SUBJECT: Recall Campaigns No. 92V-071, 92V-072 and
92V-073

RECALL CAMPAIGN

**REF. NO. 147
FUEL INJECTION LINES**

**REF. NO. 148
UPPER STEERING COLUMN
LOCKNUT**

Fig.#1a

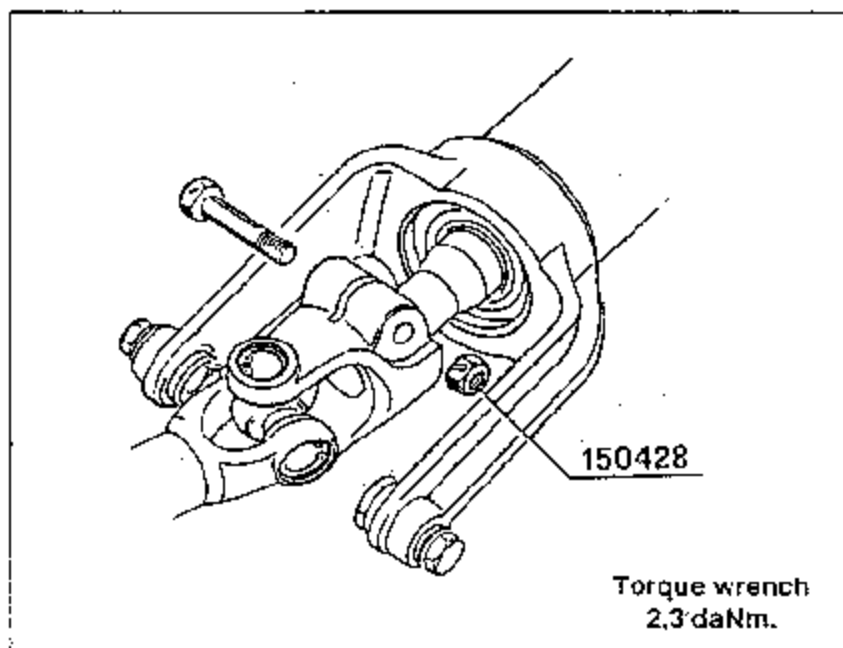
- Ferrari Testarossa, Model Year 1990 and 1991, starting from serial number 85658 up to serial number 87483 included.
- CONDITION:** The *upper steering column locknut* may have been manufactured with a lower class of material and self-locking properties. This may result in a loss of tightening torque on the upper steering column fastener. Should such condition remain unnoticed and the use of the car be prolonged for an extensive period of time, loosening of the fastener could occur resulting in play in the steering system and consequential impairment of handling.

- REMEDY:** Replacement of the Upper steering column locknut with the improved self-locking nut (shown on Fig 1, page 11).
- PARTS:** Only one locknut (PN# 150428) required for each vehicle.

A. Preliminary: The replacement self-locking nut (Fig.#1a) is supplied as a spare part (PN# 150428) by the Ferrari North America parts department.

- 1) Cover interior (seat and carpeting).
- 2) Remove 13mm locknut from upper steering column fastener and replace with new 13mm self locking nut (PN# 150428) as shown in fig.# 1 below.
- 3) Check that the steering column shaft is properly inserted into the steering column extension. Fastener must go through the groove provided in the steering column shaft.
- 4) Torque self-locking nut to 2.3 daNm (17 lbs/ft).
- 5) Check for binding in steering system. If there is binding, check system for faults.
- 6) Remove all protective covers from interior and insure that the area is clean.

Fig.#1b

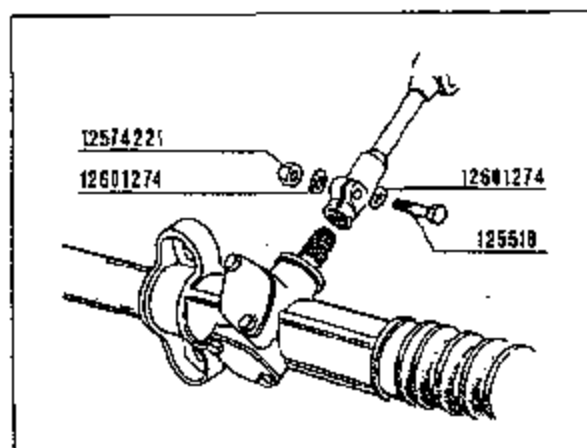
CONDITION: On 348 ts/tb vehicles with Vehicle Identification Number lower than 86212, the *steering box extension fastener* may have been manufactured with a lower class of material and self-locking properties. This may result in a loss of tightening torque on the inner steering column

- A. Preliminary: The replacement Fastener, bolt and washers (Fig.#1) are supplied as a spare parts by the Ferrari North America parts department using the part numbers listed on "parts" section of page 12.

- 3) Remove 10mm locknut from steering extension fastener and remove the fastener.
 - 4) Check that the steering box shaft is properly inserted into the steering column extension. Fastener must go through the groove provided in the steering box shaft.

- 5) Install new fastening bolt along with the two washers and locknut as shown in fig.# 1 below.
 - 6) Torque Fastener nut to 1.2 daNm (9 lbs/ft).
 - 7) Replace carpeting around area of steering extension.

Fig.#1

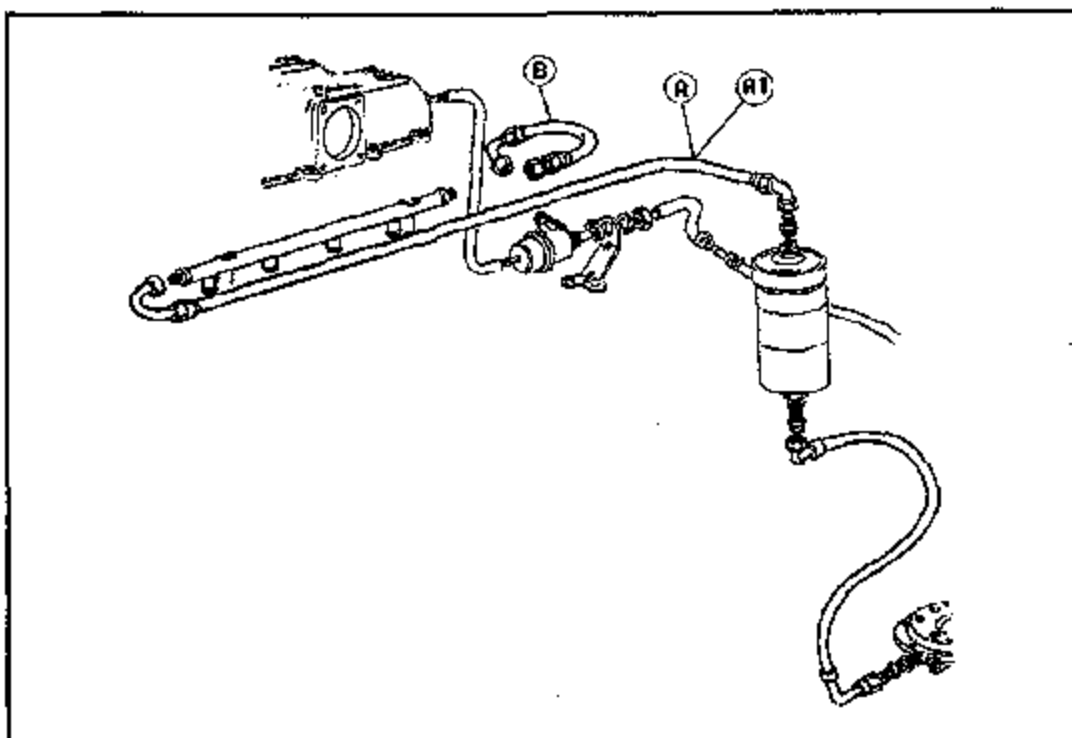
- REMEDY:** Replacement of the Fuel injection system lines "A & B" with the modified fuel lines (shown on Fig 1, page 6).
- PARTS:** Quantities required for each vehicle and identification of the new Fuel lines with the new part numbers, are shown on the Parts List Table "A" on Page 8). The new part fittings are now aluminum with a non-corrosive coating.

- 5) Remove both fuel lines "A & B" as shown in Fig.# 1 and replace with new lines.
- 6) Inspect 1/4 bank Fuel Injection return line for any damage due to contact with the timing cover. If damage is found the line must be replaced using the procedure "C - Procedure for replacement of fuel return line" found on page # 7 of this booklet. If no damage is found, please insure that the return line is secured on the clip found on the timing cover (Fig.#3). Also the Return Fuel line must not contact the Timing cover or A/C Compressor lines.
